CITY COUNCIL MEETING AGENDA MEMO

Agenda Item: Recommendation to review and deny the Right-of-Way Encroachment Permit for the heated driveway located at 308 E Canyon Run Boulevard.

RIGHT-OF-WAY GRADING AND DRAINAGE PLAN
308 E. CANYON RUN
 LOCATED WITHIN SECTION 12, T.4 N., R.17 E., B.M., CITY OF KETCHUM, BLAINE COUNTY, IDAHO
 PREPARED FOR ANDREA LAPORTE

RIGHT-OF-WAY ENCROACHMENT EXHIBIT
308 E. CANYON RUN
LOCATED WITHIN SECTION 12, T.4 N., R.17 E., B.M., CITY OF KETCHUM, BLAINE COUNTY, IDAHO
PREPARED FOR ANDREA LAPORTE

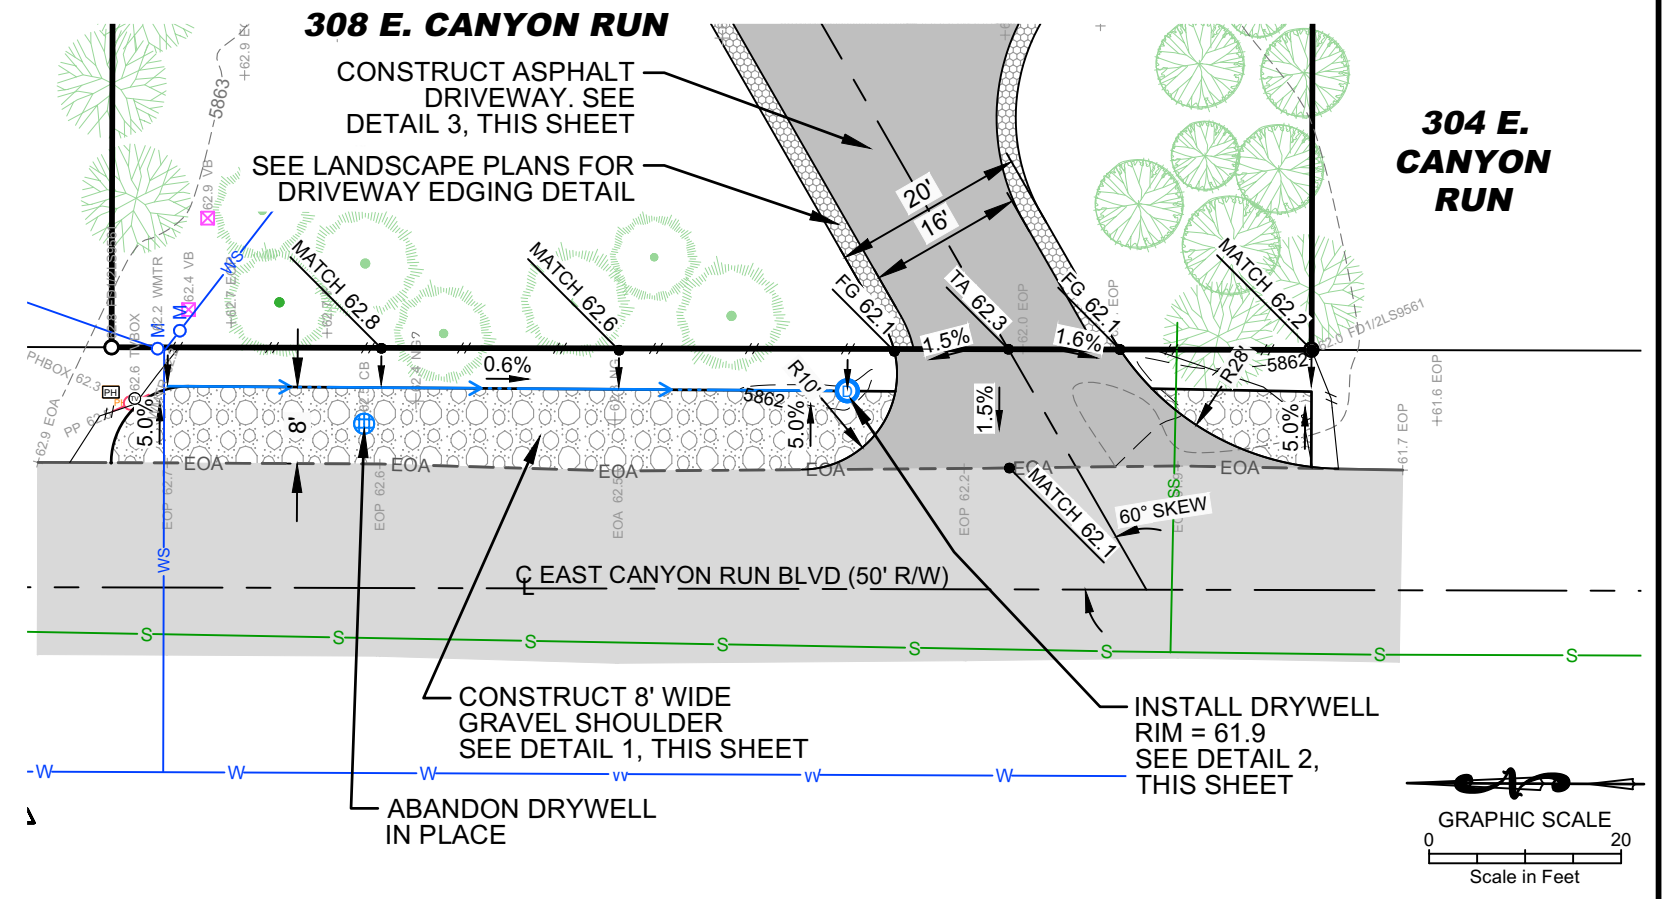
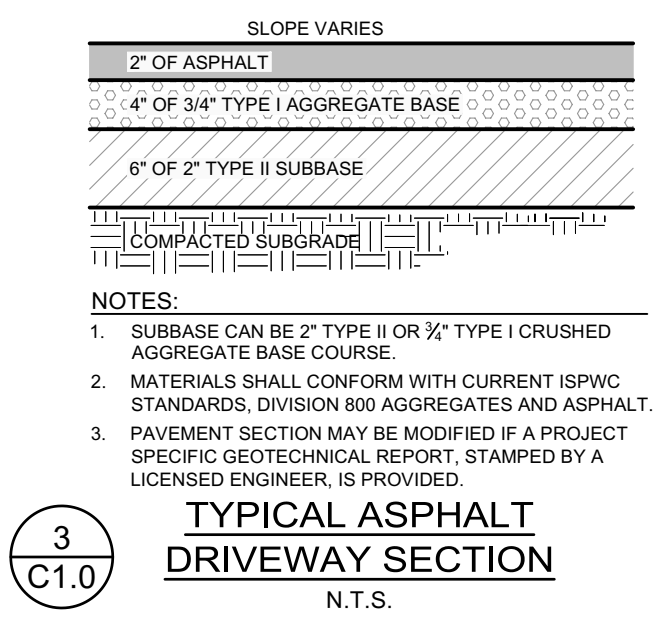
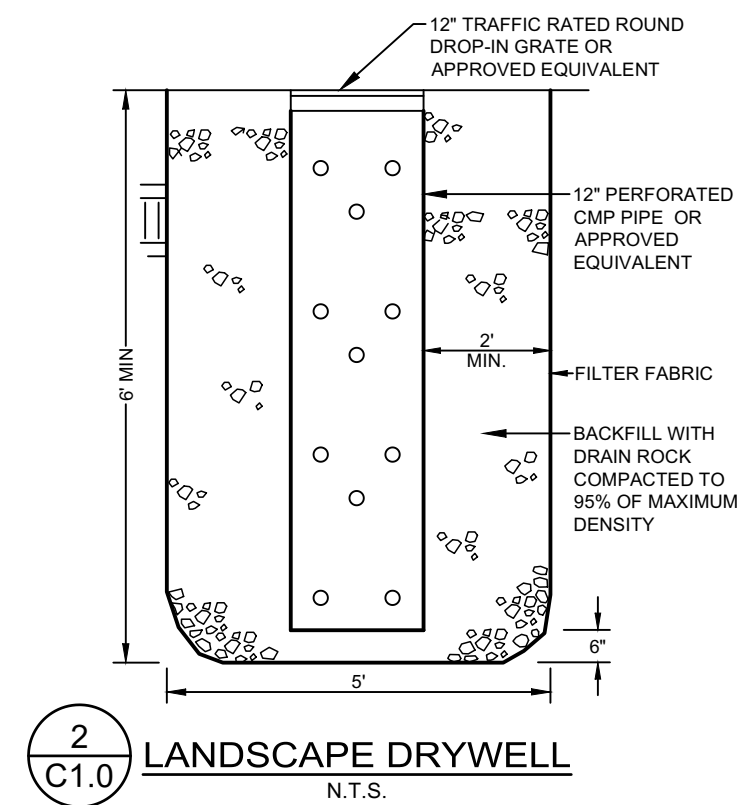
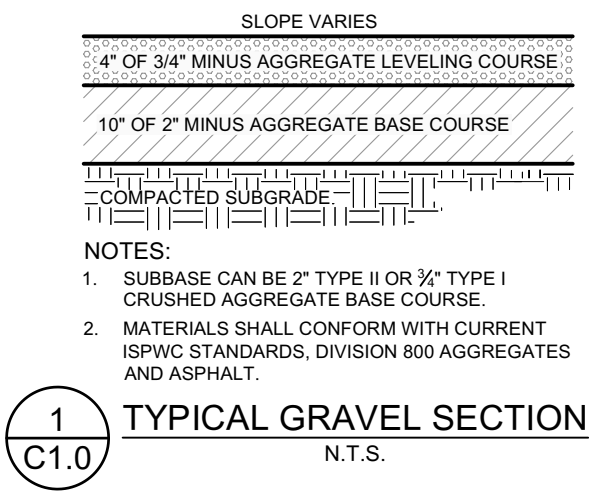
- The City of Ketchum Planning and Building Department issued Building Permit B21-015 for the construction of a new single-family residence located at 308 E Canyon Run Blvd on April 12, 2021. The project plans approved with Building Permit B21-015 (see Attachment 1) specified that the driveway was proposed to be surfaced with asphalt and was unheated. Planning staff conducted a final inspection for the project on February 12, 2024 and found that the driveway had not been constructed in accordance with the project plans approved with Building Permit B21-015 (see Attachment 1).

The City of Ketchum Planning and Building Department issued Building Permit B21-015 for the construction of a new single-family residence located at 308 E Canyon Run Blvd on April 12, 2021. The project plans approved with Building Permit B21-015 (see Attachment 1) specified that the driveway was proposed to be surfaced with asphalt and was unheated. Planning staff conducted a final inspection for the project on February 12, 2024 and found that the driveway had not been constructed in accordance with the project plans approved with Building Permit B21-015 (see Attachment 1).

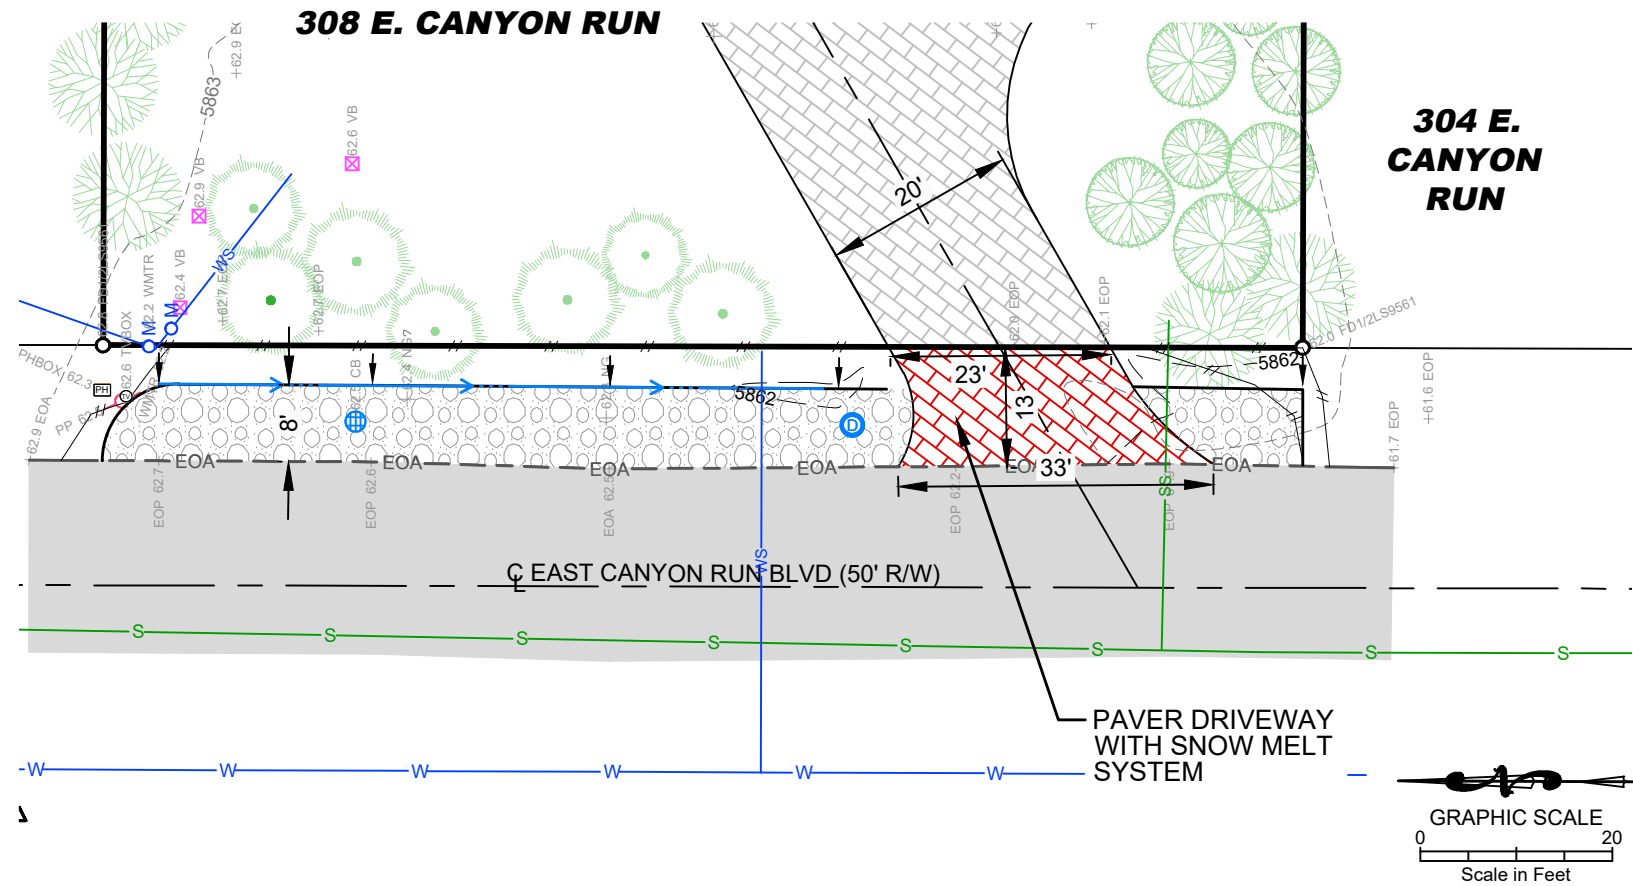
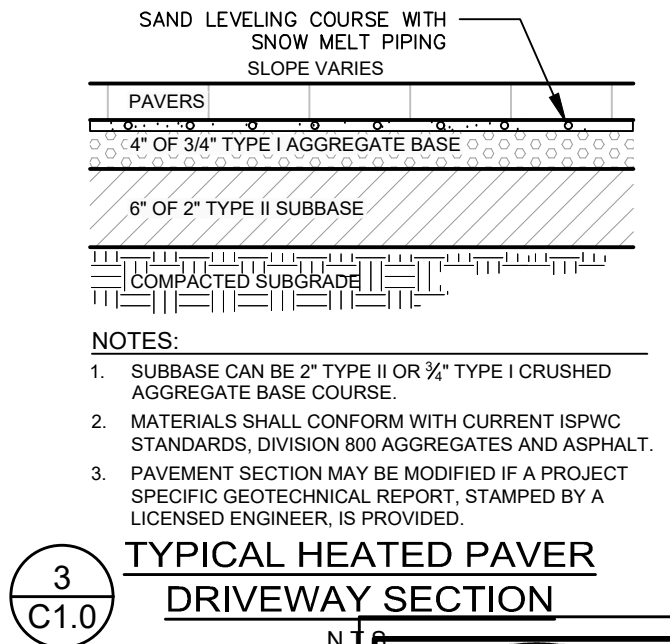
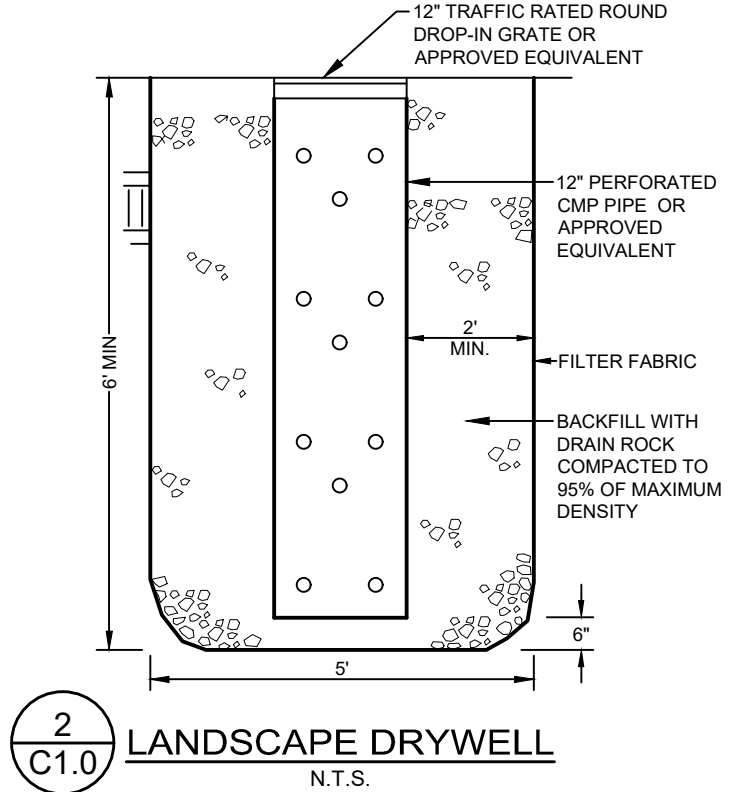
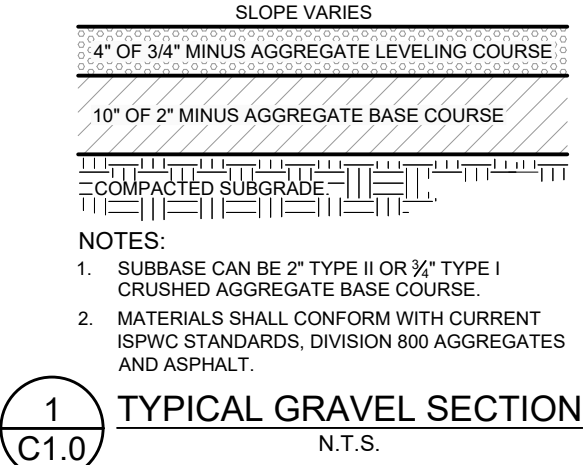
- As shown in Attachment 2, the driveway is surfaced with heated pavers, and the snowmelt system encroaches within the public right-of-way along East Canyon Run Blvd. The unpermitted driveway improvements were constructed without city review or approval. Pursuant to section R106.4 of the 2018 International Residential Code, “Work shall be installed in accordance with the approved construction documents, and any changes made during construction that are not in compliance with the approved construction documents shall be resubmitted for approval as an amended set of construction documents.”

- The driveway conforms to city standards and a snowmelt system is not recommended by the Fire Department or Streets Department. Based on City Council’s policy direction regarding residential snowmelt systems provided on April 3, 2023, staff directed the applicant to remove the portion of the snowmelt system that encroaches within the public right-of-way. The applicant contested staff’s direction and requested this matter be presented to the City Council for their consideration.

As shown in Attachment 2, the driveway is surfaced with heated pavers, and the snowmelt system encroaches within the public right-of-way along East Canyon Run Blvd. The unpermitted driveway improvements were constructed without city review or approval. Pursuant to section R106.4 of the 2018 International Residential Code, "Work shall be installed in accordance with the approved construction documents, and any changes made during construction that are not in compliance with the approved construction documents shall be resubmitted for approval as an amended set of construction documents."

The driveway conforms to city standards and a snowmelt system is not recommended by the Fire Department or Streets Department. Based on City Council's policy direction regarding residential snowmelt systems provided on April 3, 2023, staff directed the applicant to remove the portion of the snowmelt system that encroaches within the public right-of-way. The applicant contested staff's direction and requested this matter be presented to the City Council for their consideration.

- Option 1—Staff recommends the following motion based on policy direction provided to staff on April 3, 2023 that the City Council will no longer approve Right-of-Way Encroachment Permits for residential snowmelt systems: “I move to deny the Right-of-Way Encroachment Permit for the 308 E Canyon Run Blvd heated driveway and direct the applicant to remove the portion of the snowmelt system that encroaches into the right-of-way.”

Based on the policy direction provided by the City Council on April 3, 2023, staff recommends that the City Council deny the Right-of-Way Encroachment Permit as the driveway conforms to city standards and a snowmelt system is not recommended by the Streets Department or Fire Department (see Motion Option 1). If the City Council chooses to amend their policy direction to approve snowmelt systems for residential driveways encroaching in the public right-of-way, then the 308 E Canyon Run Blvd Right-of-Way Encroachment Permit may be approved (see Motion Option 2).
